Pacific Gas and Electric Company
2022 Wildfire Mitigation Plan
Response to Revision Notice

RN-PG&E-22-01
RN-PG&E-22-06
RN-PG&E-22-07
RN-PG&E-22-08
RN-PG&E-22-10
RN-PG&E-22-11
RN-PG&E-22-13

June 27, 2022

Figure RN-PG&E-22-07-01: HFTD Distribution Ignitions Forecast Waterfall

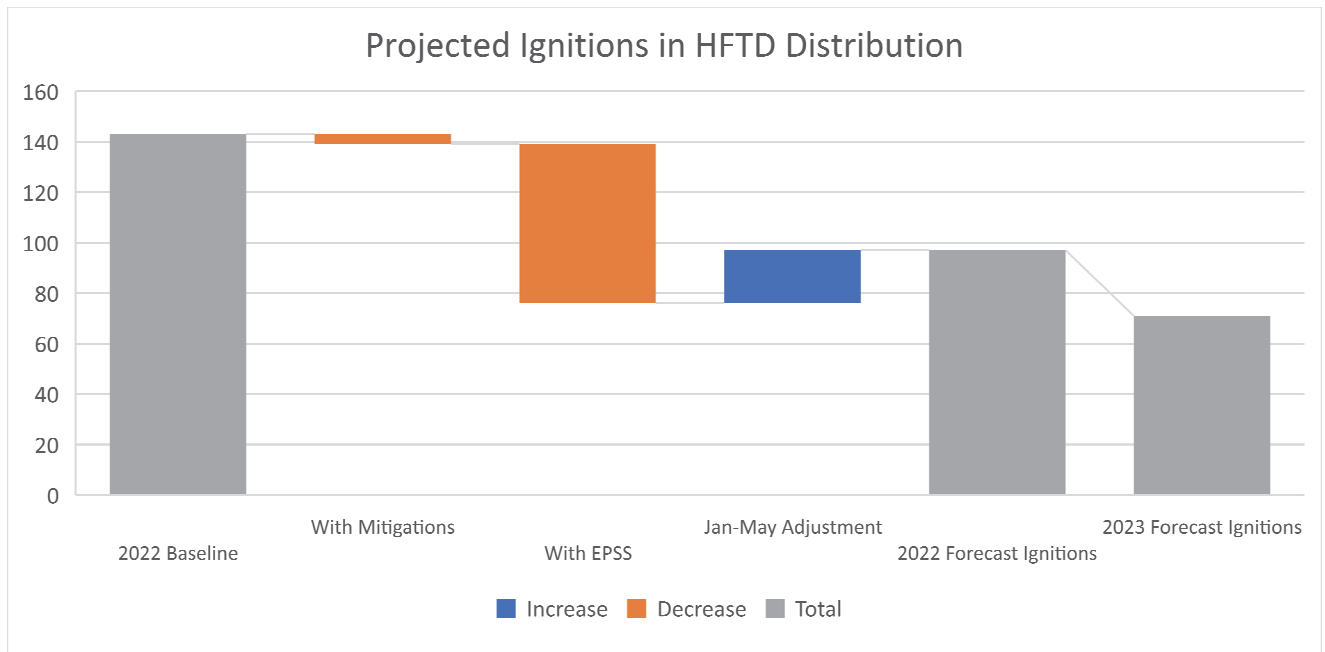
1. *PG&E must revise and resubmit Table 7.2 from PG&E’s 2022 Update to project 2022 and 2023 ignitions factoring in risk reduction benefits of mitigation measures, including (but not limited to) EPSS, undergrounding, and covered conductor.*

2. *PG&E must also provide a narrative description for what factors are considered when calculating ignition projections, inclusive of WMP mitigation measure implementation, the weights of such factors and effects on projected ignitions.*

For 2023 year-end value, we project HFTD distribution 71 ignitions, after accounting for our continued mitigations, with a 95% confidence interval, and a range of 54 to 87 ignitions. This figure could also substantially change as we continue to evaluate the impacts of EPSS settings on our system. This represents our best available information as of June 2022 and will continue to provide adjustments and updated data as part of our quarterly and annual WMP reporting.

Figure RN-PG&E-22-07-01 below summarizes the changes to the HFTD ignition projections described above.
